RE: Enterprise Recycling & Disposal Class III Landfill  
Permit Nos.: 177982-001-SC and 177982-002-SO, Pasco County  
Certification of Construction Completion, Cell 4 (approximately 7.34 acres)

RE: Enterprise Class III Landfill  
Cell 4 Construction Completion Report  
Request for Additional Information  
Angelo's Aggregate Materials, Ltd.  
FDEP Permit Nos. 177982-001-SC and 177982-002-SO  
Pasco County, Florida

**Subject: Response to Comments, dated December 5, 2005  
Enterprise Recycling & Disposal Facility  
FDEP Permit No. 177982-001-SC, 177982-002-SO  
Pasco County, Florida**

**Subject: Response to Cell 16 and Cell 1 Certification Comments  
Enterprise Recycling & Disposal Facility  
Angelo's Aggregate Materials, Ltd.  
FDEP Permit Nos. 177982-001-SC, 177982-002-SO  
Pasco County, Florida**

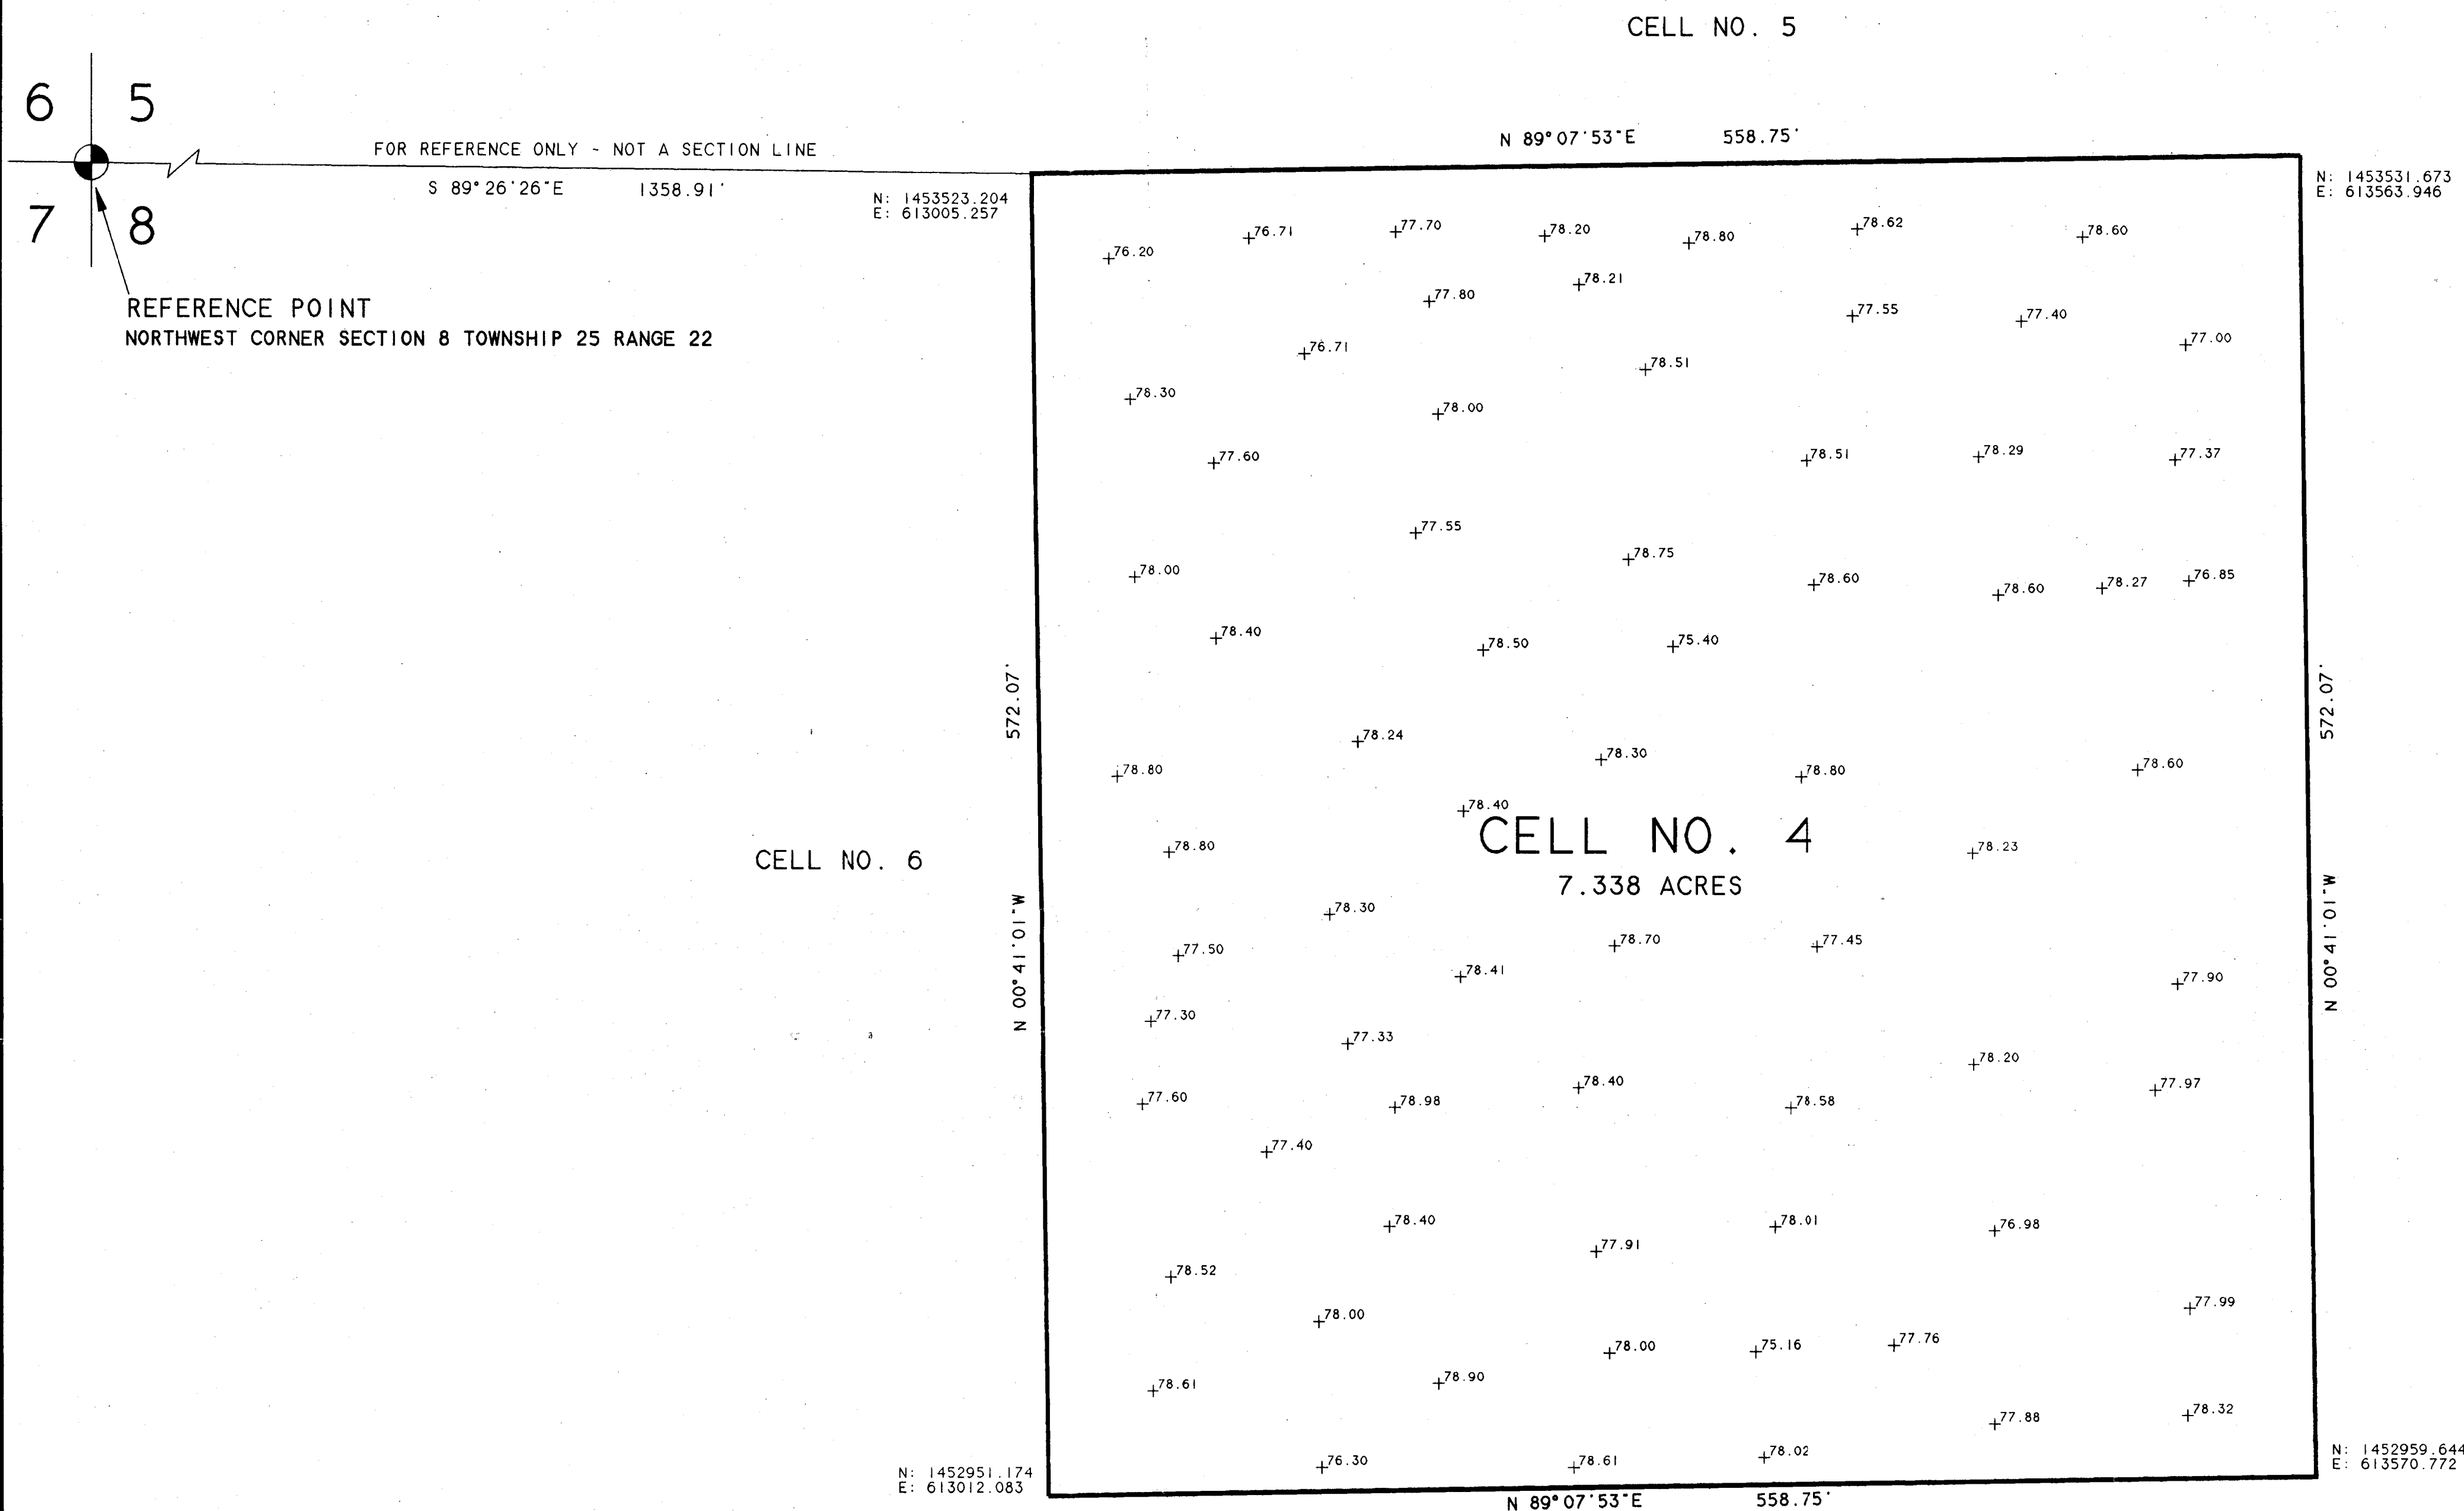
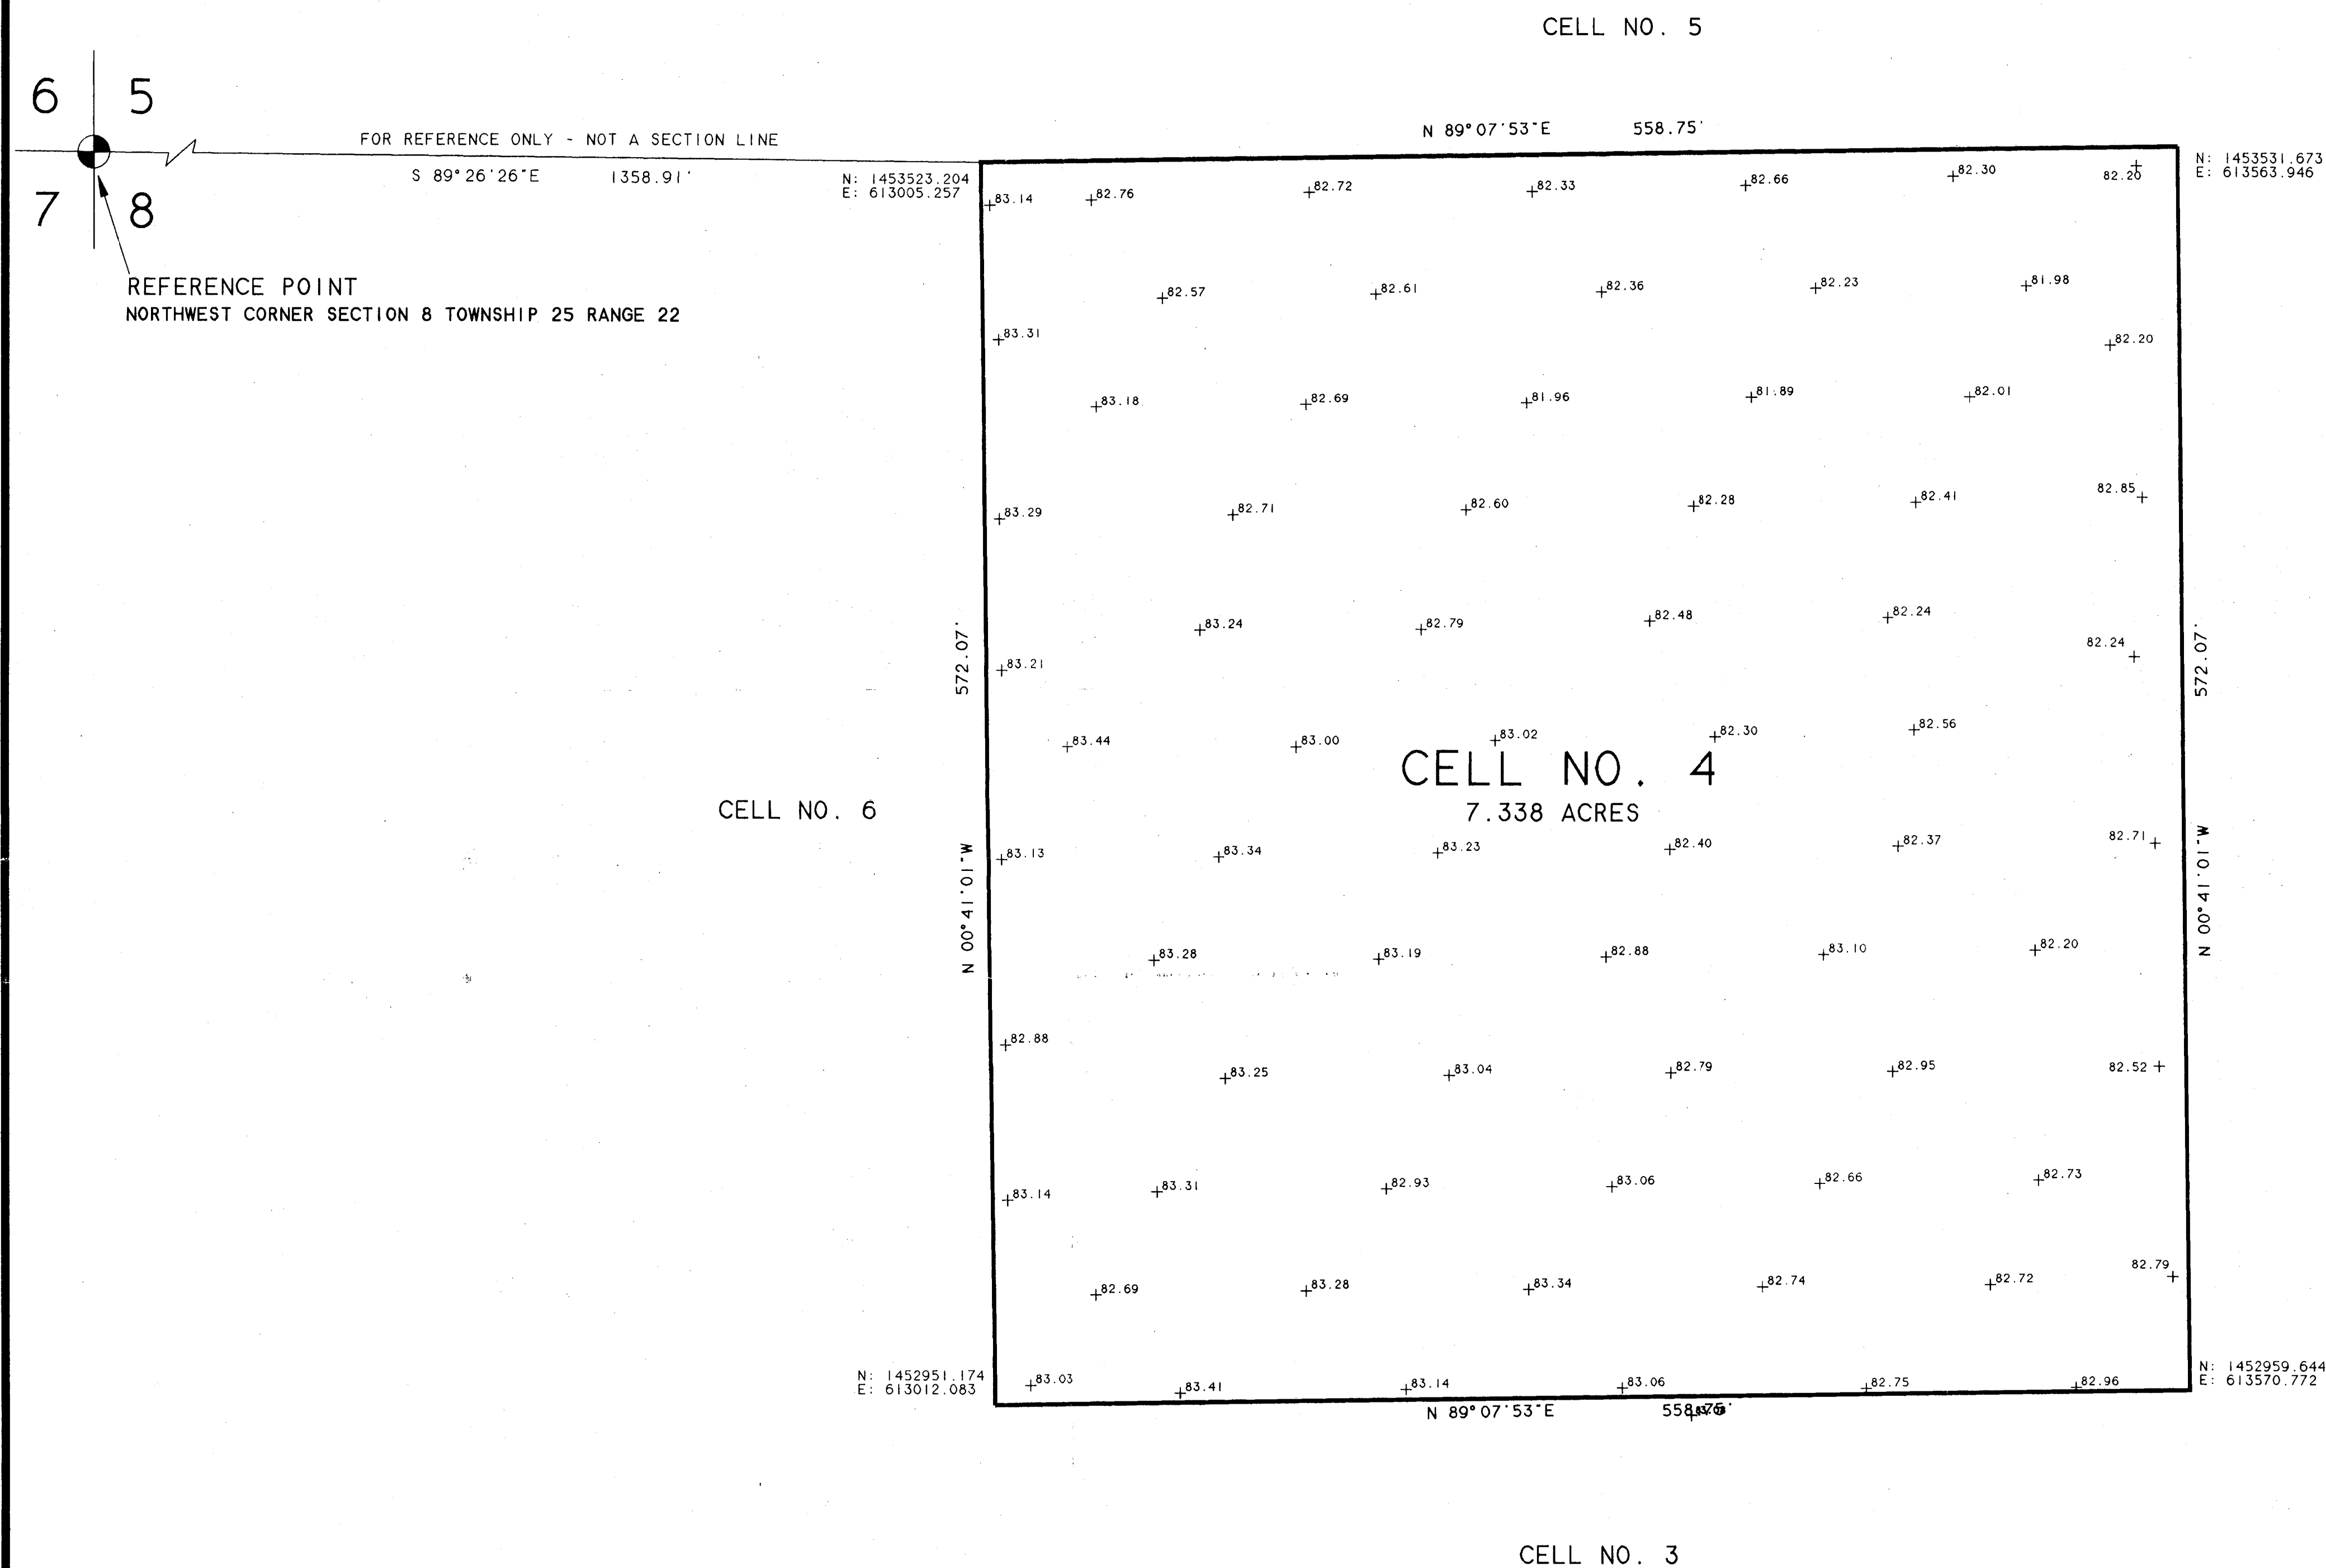
**Comment No.1: Please provide surveys that indicate which layer is included in the survey (i.e., subbase or top of confining/clay layer).**

Response No.1: Signed and sealed drawings of both the "top of clay" and "top of subgrade" are provided in Attachment A of this response. The "subgrade" or "subbase" is the top of the excavation, prior to backfilling with clay. The "top of clay" is the top of the finished 3' clay layer.
